1
2 **DOCUMENT 00 91 13**
3

8 ADDENDUM NO.1 Date: 08.02.21
9

10 RE: SAUK COUNTY COURTHOUSE AND HUMAN SERVICES BUILDING RENOVATIONS
11 515 OAK STREET, BARABOO, WI 53913 and
12 425 6TH STREET, REEDSBURG, WI 53959
13

04
C102.1 DRAIN TILE IN DRAIN ROCK

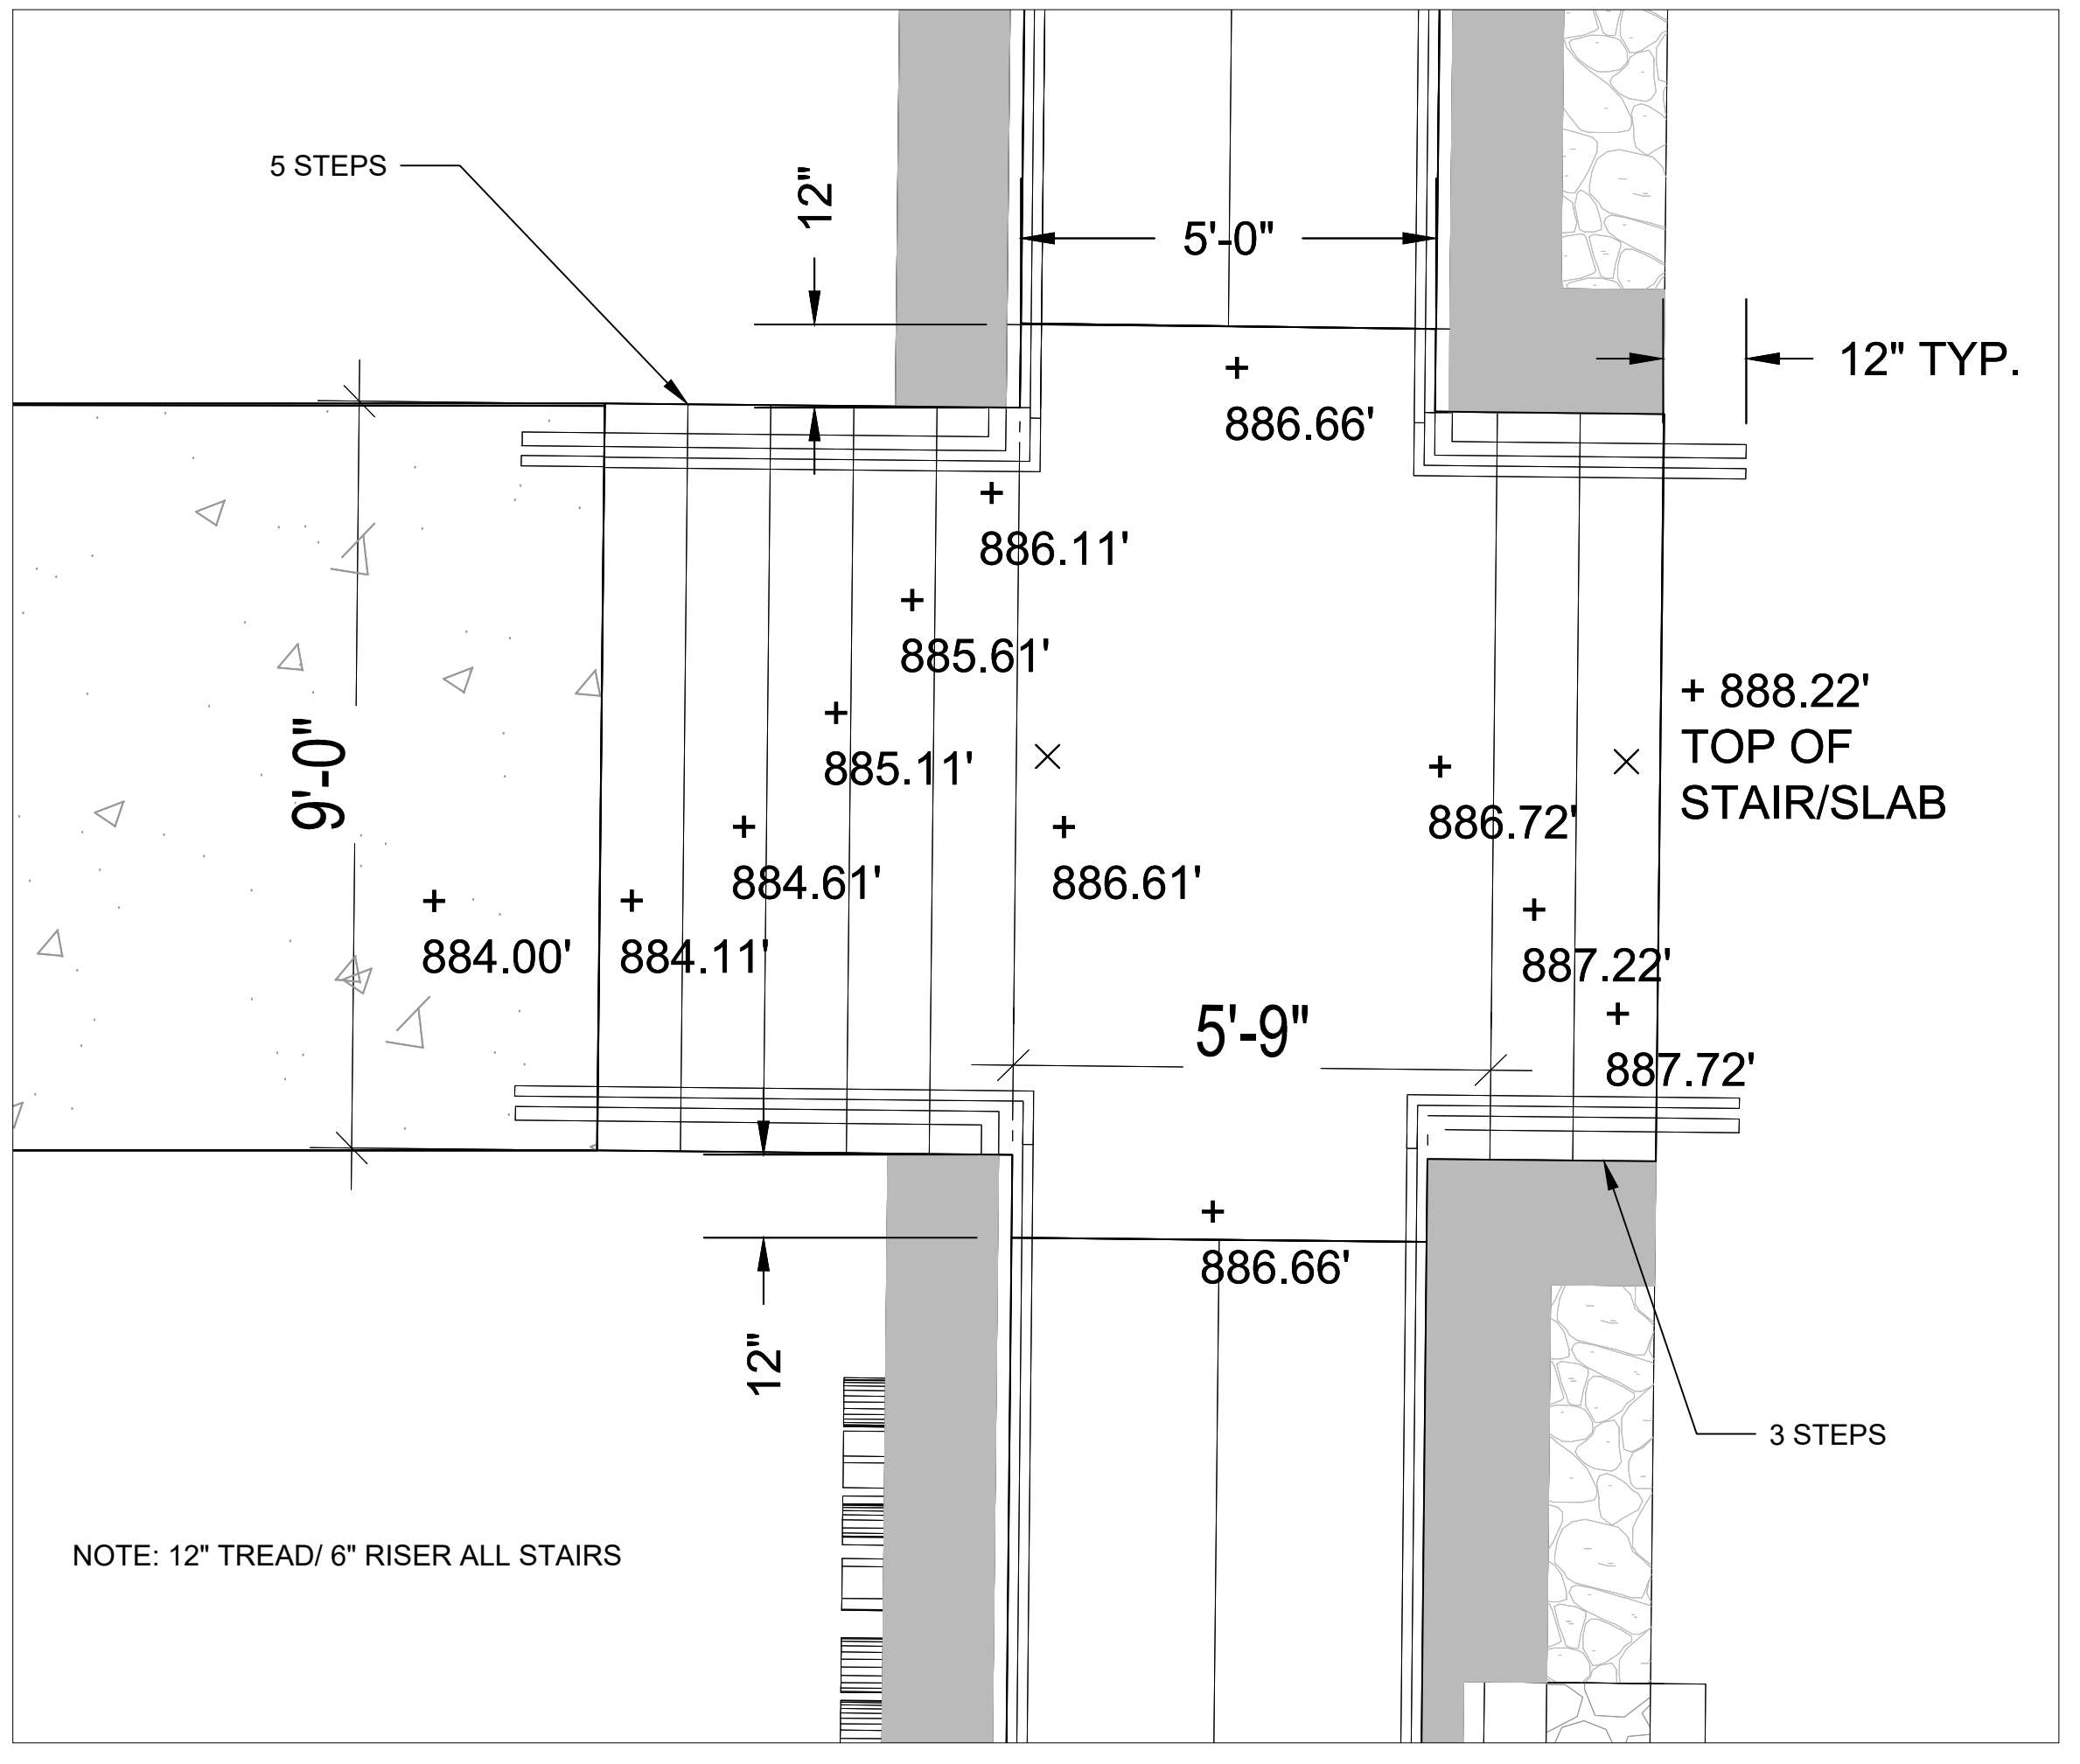
- 13
14 1. SHEET C102.1, CIVIL SITE PLAN
15 a. Replace sheet C102.1 in its entirety with attached C102.1.
16 b. Added drain tile in gravel garden behind retaining wall.
17 c. Added drain tile detail.
18 d. Updated site quantities.
19 e. Updated notes about salvaged topsoil (4) and drain tile (23).
20 f. Moved 885.0 contour to front face of retaining wall.
21
22 2. SHEET C103.1, SITE RESTORATION PLAN
23 a. Replace sheet C103.1 in its entirety with attached C103.1.
24 b. Revised gravel garden detail.
25 c. Updated planting notes re: topsoil spec (2) and gravel garden (7).
26 d. Revised plant species, spacing, and quantities.
27
28 3. SHEET D201.1, FIRST FLOOR DEMOLITION PLAN
29 a. Demolition Plan Key Notes: Add demolition note 20 Remove hardware and modify
30 existing door and frame for installation of scheduled hardware, see 08 71 00.
31 b. First Floor Demolition Plan: Add Demolition Key Note 20 at door openings 156, 177 and
